Finding of Suitability to Transfer #9 for Carve-Out II-F-3

Former Marine Corps Air Station El Toro Irvine, California

January 26, 2017

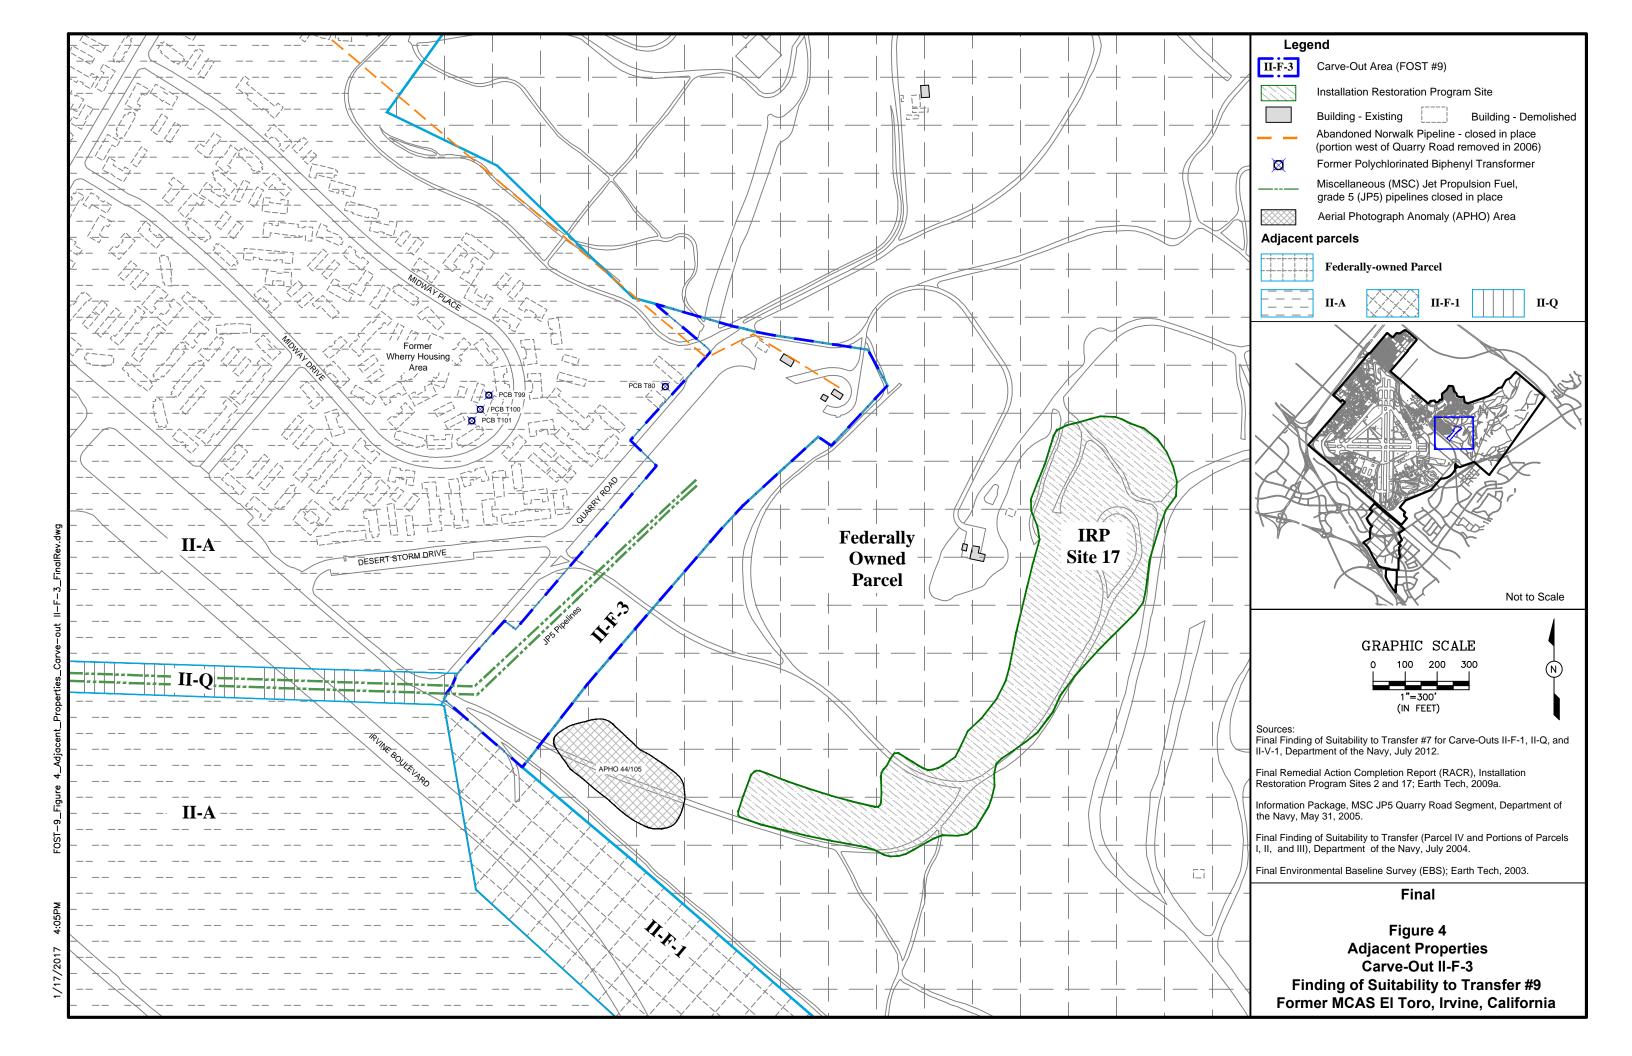
Number	Reference	Comment	Response
			(Earth Tech 2009b).
4	Figure 3	The EBS (Figure 6-1a) shows PCB 547 within CO II-F-3, however, PCB 547 is not shown on FOST #9 (Figure 3). Please explain the discrepancy.	PCB 547 is listed in Attachment 4 of Draft FOST #9 as a non-transformer PCB item associated with a former tank vault structure at underground storage tank (UST) 547. This vault was located on the top and near the center of the UST (Figure 3 of Draft FOST #9), which makes the location shown on EBS Figure 6-1a appear to be incorrect. A triangle symbol depicting PCB 547 will be added to Figure 3 at approximately the location of the vault on UST 547. In addition, the "Area Type ID" entry in Attachment 4 will be modified to "Non-Trans 547 (PCB 547)," and the "Building/Structure Number" will be modified to "UST 547".
5	Figure 3	The locations of the underground storage tanks appear to be different when comparing the EBS (Figure 6-1a) with FOST #9 (Figure 3). Please explain the discrepancies.	Upon further review, Figure 6a in the EBS contains the following errors: UST 548 is in the incorrect location (it should not be adjacent to UST 547); UST 549 is mislabeled and should be labeled as UST 548; and the actual UST 549 location is not shown. The other locations are correct and depict the center locations of the USTs. Please note that in the EBS the locations are depicted as points (i.e., centers of the USTs), while various former Tank Farm 555 documents contain much more detailed maps that depict the actual UST diameters (88 feet) and locations. Therefore, the detailed locations and accurate diameters depicted in the former Tank Farm 555 documents were used for Figure 3 in Draft FOST #9. Examples are Figure 3 in the <i>Site Assessment Report, Underground Storage Tanks 548 and 551</i> (DON 1998; precedes the EBS); Figures 2 and 3 in the <i>Summary Report, Petroleum Release at the Large Tank Area, Former Tank Farm 555</i> (DON 2010); and Figures 2 and 3 in the <i>Final Tank Closure Report, Inspection and Closure of Former Tank Farm 555</i> (RORE, Inc. 2016b; note that Figure 3 is an engineering design drawing). These former Tank Farm 555 documents are all consistent in their depiction of the locations of the USTs.

Number	Reference	Comment	Response
			and/or final version of FOST #9.
5	Page 6, Section 4.2.4	a. This section discusses the Defense Fuel Support Point Norwalk pipeline. Figure 3 shows an abandoned Norwalk Pipeline and a Residual Fuel Pipeline. Are these one in the same? Please explain.	a. Figure 3 shows these as separate features that are symbolized differently; they are not the same. As noted in Section 4.2.1, the former Defense Fuel Support Point Norwalk pipeline supplied fuel to former Tank Farm 555. The residual fuel pipeline extended from Building 556 to former USTs 553 and 554. To clarify the difference, the following will be added to Section 4.2.1 before the last sentence of paragraph 1: An 8-inch-diameter pipeline conveyed fuel between Building 556 and former USTs 553 and 554; this pipeline was closed in place (Figure 3; DON 1997). Furthermore, on Figure 3, the "residual fuel pipeline" will be renamed "fuel pipeline to USTs 553 and 554 – closed in place" to be consistent with the Summary Report, Former Underground Storage Tank Sites 553 and 554 (DON 1997). Because the

b. Why aren't the Norwalk and Residual Fuel Pipelines (shown on Figure 3) included as LOCs in Table 3?	b. With regard to the former Defense Fuel Support Point Norwalk pipeline, please refer to the response to DTSC Specific Comment #5b.
			The residual fuel pipeline was not explicitly listed in the EBS as a LOC, nor was it defined in documents as part of MSC JP5 (Table 4-14 of the EBS [Earth Tech 2003]); therefore, it was also excluded from Table 3 in Draft FOST #9. However, because the residual fuel line was part of the UST 553 and 554 system, this association will be clarified in Table 3 by replacing the first sentence in the Notes for UST 553 with the following:
			The UST was connected to Building 556 via an 8-inch-diameter fuel pipeline; this pipeline was cut and capped on the east side of the

Number	Reference	Comment	Response
		(a) and UST 551 should include note (c).	
		e. Why isn't all the information included in Section 4.3 regarding the work done by RORE included in this table? The table references RORE 2016a, but not RORE 2016b. Please explain.	e. The RORE, Inc. (2016b) reference will be added to the table. All applicable information is already included.
13	Figure 2	Have COs II-C and II-D-1 been transferred?	No, not at the time of this response. However, transfer of these two COs is expected by 31 January 2017, so no changes to Figure 2 are currently necessary. Should these COs not be transferred by the time Final FOST #9 is signed, Figure 2 will be revised appropriately.
14	Figure 3	a. There is an existing building shown near PCB T122 that is not shown in Table 1. Please explain.	a. This feature is the former concrete pad associated with former transformer PCB T122. It will be removed from Figure 3.

b. There are two demolished buildings shown on the figure. One is labeled 553 and another, located just above UST T-1, is not labeled. Please provide a label.	b. Based on re-review of the <i>Summary Report, Petroleum Release at the MSC JP5 Building 556 Study Area</i> (DON 2009c), this feature may be a structure formerly associated with UST T-1 or it may represent UST T-1 itself, based on its location. The only labeled feature at this location is UST T-1. Therefore, the feature will be removed from Figure 3 and the UST T-1 orange square symbol will be moved over to replace it. Please also see DON-Initiated Correction #1 below regarding the correction of the location of UST T-1.
15	Figure 4	a. Please see Specific Comment #14a above.b. Why are the JP5 Pipelines shown on this figure, but not the Norwalk Pipeline?	a. Please see the response to DTSC Specific Comment #14a.b. The former Defense Fuel Support Point Norwalk pipeline will be added to Figure 4; please also refer to the response to DTSC Specific Comment #7.

subsequent Summary Report, Petroleum Release at the MSC JP5 Building 556 Study Area (DON 2009c) also refers to this pipeline as the "residual" or "contaminated" fuel pipeline, the following footnote will be added to the Figure 3 pipeline description: The fuel pipeline between Building 556 and USTs 553 and 554, documented as a fill pipe in the Summary Report, Former Underground Storage Tank Sites 553 and 554 (DON 1997) was also referred to as the "residual" or "contaminated" fuel pipeline in the subsequent Summary Report, Petroleum Release at the MSC JP5 Building 556 Study Area (DON 2009c).
			In addition, based upon further review of the figures and information in the <i>Summary Report, Former Underground Storage Tank Sites 553 and 554</i> (DON 1997) and the <i>Tank Closure Report, Underground Storage Tank (UST) T-1</i> (IT Group 2000), the locations of USTs T-1, 553, and 554 depicted on Figure 3 of Draft FOST #9 will be moved to their correct locations near the northwestern end of the residual fuel pipeline, just inside the fence. Finally, as a result of the further document review relating to the locations of these USTs, to further clarify the use and location of UST T-1, the following will be added to the Notes in Table 3 for UST T-1:

Number	Reference	Comment	Resnonse
Number	Reference	Comment	Response excavation during tank removal activities. Please note that as explained the response to DTSC Specific Comment #5a, the "residual fuel pipeline" on Figure 3 will be renamed. In addition, to be consistent with the response to DTSC Specific Comment #5a, the following footnote will be added to Table 3 regarding the fuel pipeline between Building 556 and USTs 553 and 554: The fuel pipeline between Building 556 and USTs 553 and 554 was documented as a fill pipe in the Summary Report, Former Underground Storage Tank Sites 553 and 554 (DON 1997) but was also referred to as the "residual" or "contaminated" fuel pipeline in the subsequent Summary Report, Petroleum Release at the MSC JP5 Building 556 Study Area (DON 2009c).

Number	Reference	Correction	Rationale
1	Figure 3	The locations of USTs T-1, 553, and 554 will be corrected. The "residual fuel pipeline" will be renamed to "fuel pipeline to USTs 553 and 554 – closed in place", and a footnote will be added indicating that the pipeline has also been referred to as the "residual" or "contaminated" fuel pipeline. In addition, the former concrete pad associated with former transformer PCB T122 and the unlabeled demolished building shown just above UST T-1 will be removed.	UST T-1 was used to store residual/waste JP5 spilled from truck loading operations and was located on the north side of the paved access road. Its depiction along the fence line was incorrect. USTs 553 and 554 were also incorrectly depicted as being located outside the fence line. The pipeline description is being changed to be consistent with the Summary Report, Former Underground Storage Tank Sites 553 and 554 (DON 1997), but it will be noted that the Summary Report, Petroleum Release at the MSC JP5 Building 556 Study Area (DON 2009c) described it differently. It is not necessary to depict the former concrete pad associated with former transformer PCB T122. The unlabeled demolished building was never present.
